Technical Service Bulletin: tsb103980

Released Date: 11-Nov-2009

New Alternator and Accessory Drive Seal

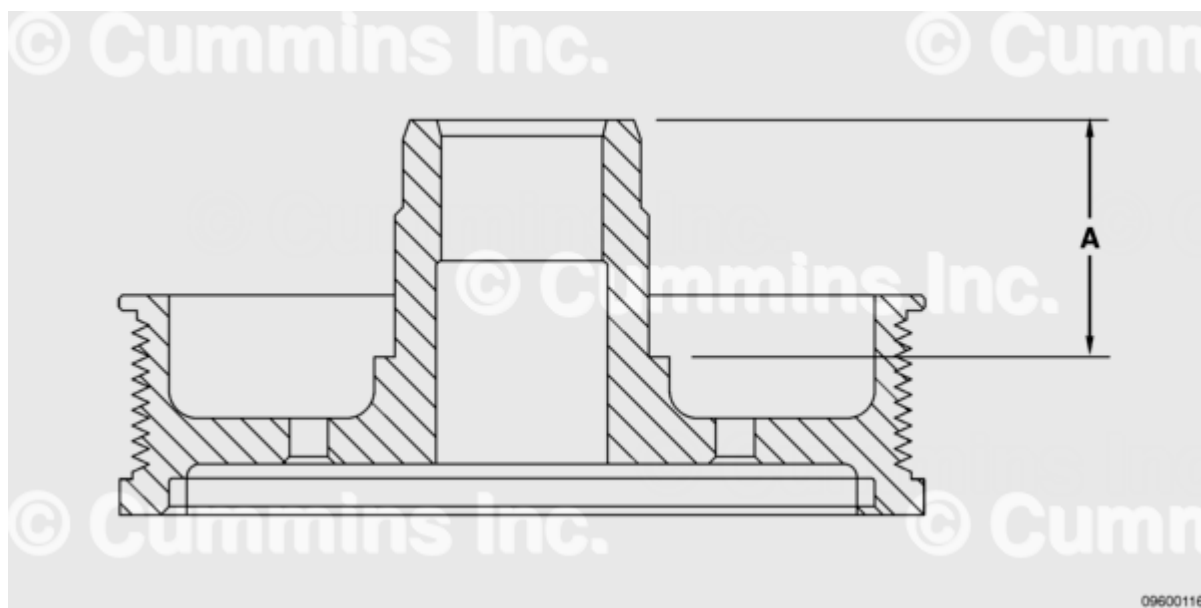
This Service/Parts Topic introduces new accessory and alternator drive seal and pulleys for the QSK45 and QSK60 engines. The new accessory and alternator drive seal, Part Number 4080404, replaces the old accessory drive seal, Part Number 3171909. The new accessory drive seal will be included in Service Kit, Part Number 4085931. The service kit contains the items listed in Table 1.

The new accessory and alternator drive seal is **not** a direct replacement for the old accessory and alternator drive seal. As a result, modification of the old pulley or installation of a new pulley is required. Refer to Table 2, Accessory and Alternator Drive Seal Matrix, below.

Accessory and Alternator Drive Seal Service Procedure Matrix

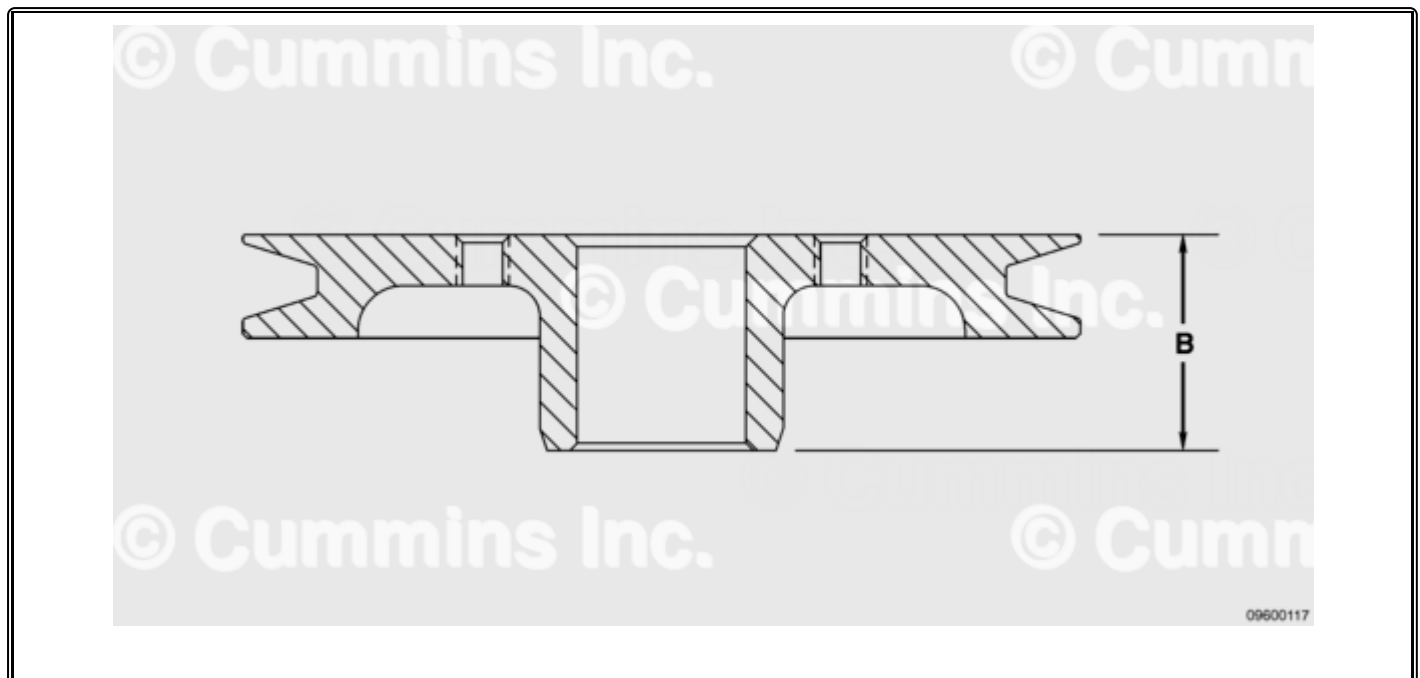
If replacing the old accessory and alternator drive seal, Part Number 3171909, the following information applies. Refer to Table 2 for the correct procedure.

**Alternator Drive Seal, Right Bank**

Remove the alternator drive pulley and perform one of the following:

1. Machine 2.1 mm [0.08 in] From the length A of the pulley or
2. Purchase a new pulley. See Table 3 for the correct new pulley part number.

Accessory Drive Seal, Left Bank

Remove the accessory drive pulley and perform one of the following:

- Reuse the old pulley by installing the spacer, to increase the distance (B), provided in the seal service kit or
- Purchase a new pulley. See Table 4 for the correct new pulley part number.
